**SUBJECT:** DE 09-277: Petition by Public Service Company of New Hampshire for a License to Construct and Maintain Electric Lines, a Static Wire, and/or a Fiber Optic Communications Cable over the Bean River, North River, and Little River in Nottingham, the Oyster River in Barrington, and the Dube Brook and the Oyster River in Lee, New Hampshire

**Accion Group Review of the Public Service Company of New Hampshire Petition for License to Construct and Maintain Electric Lines, a static Wire, and/or a Fiber Optic Communications Cable Over and Across the Public Waters of the Bean River, North River, and Little River in Nottingham, the Oyster River in Barrington, and the Dube Brook and Oyster River in Lee**

**January 18, 2010**

Photo #3 – Appendix B – NH Route 152

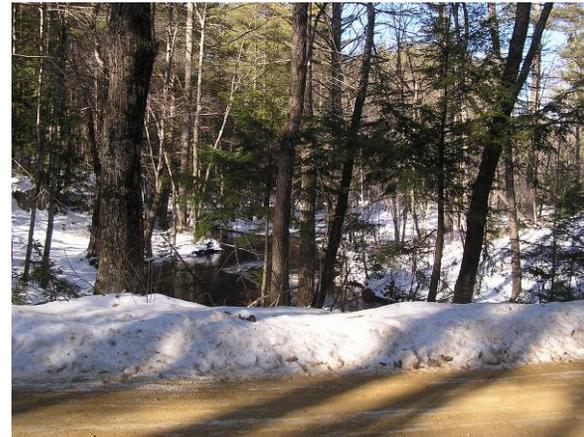
PSNH states that the portion of the North River crossed in Appendix B and the portion of the Little River crossed in Appendix C are not suitable for sail boating. On January 15, 2010, Accion performed a site visit and took photographs of the crossings in Appendices B and C which PSNH claims to not be suitable for sail boating. Photographs of the crossings in Appendices B and C appear as Attachment G to this report. Accion concluded that the PSNH assessment was correct and is described directly below.

PSNH states that the portion of the North River crossed in Appendix B is not suitable for sail boating because the river is impounded to the South by a box culvert at NH Route 152 at an elevation of 240 feet to the top of the culvert. With a 100-year flood elevation of 240 feet, no vessel would be able to pass through the culvert. Photo #3 shows the water level which is approximately 5 feet below the top of the culvert and that at the flood design level, sail boats could not traverse the brush to the proposed crossing. To the north and east of the crossing, the North River splits and is culverted at Freeman Hall Road and Priest Road. At Freeman Hall Road, the top of the culvert is at an elevation of 299 feet, well above the 240 foot 100-year flood elevation. At this elevation, FEMA states that the river would not flow outside of its banks and would have a depth of 1 foot during the 100-year event. Photo #1 shows that wooded terrain at this location prevents access at the flood design level. At Priest Road, the top of the culvert elevation is 244 feet, again restricting passage during a 100-year event of an elevation of 240 feet. Photo #2 shows that there is no reasonable access at this location even at the flood design level. Additionally, PSNH states that there are no other access roads or boat ramps to launch a sailboat. The Accion site visit found no further point of access to the proposed crossing.
